OICA PROPOSAL FOR AMENDMENTS TO REGULATION No. 48

The text reproduced below was prepared by the expert from OICA to amend document ECE/TRANS/WP.29/GRE/2009/34 submitted by the GRE Chairman, regarding Regulation No. 48 and in particular the automatic switching of the dipped beam headlamps installed on a vehicle equipped with daytime running lamps.

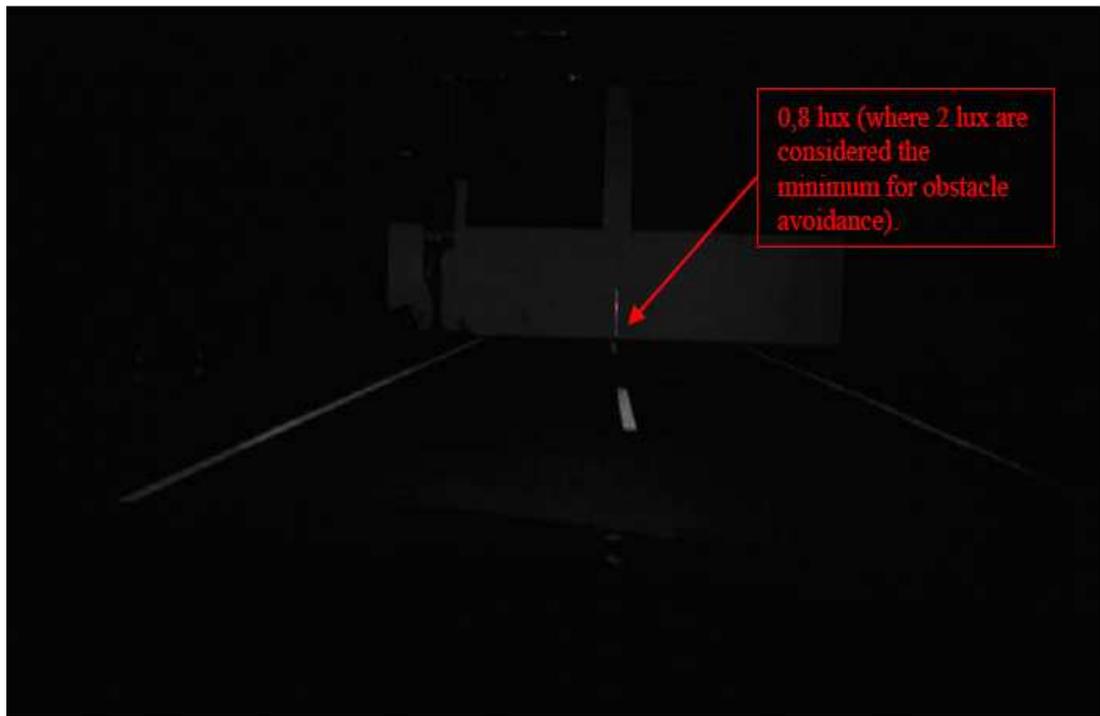
Evaluating the situation described in para. 6.2.7.6., one has to differentiate between two different scenarios.

The first scenario occurs when the ambient light outside the vehicle is strongly reduced. The pictures below show clearly that a driver driving with DRL on will switch to the dipped beams (low beams) when it becomes dark, even without the assistance of an AHS.

The second scenario occurs when the ambient light is moderately reduced like in urban areas and tunnels. In this case it may happen that drivers forget to switch on the dipped beams when it becomes dark. Nevertheless other drivers will still be able to notice the vehicle because of the outside ambient lighting and the vehicle rear retro-reflectors. Therefore from a safety perspective it should be enough to provide distinctive means to inform the driver that the headlamps, position lamps and if so equipped end outline marker lamps and side marker lamps are not illuminated.
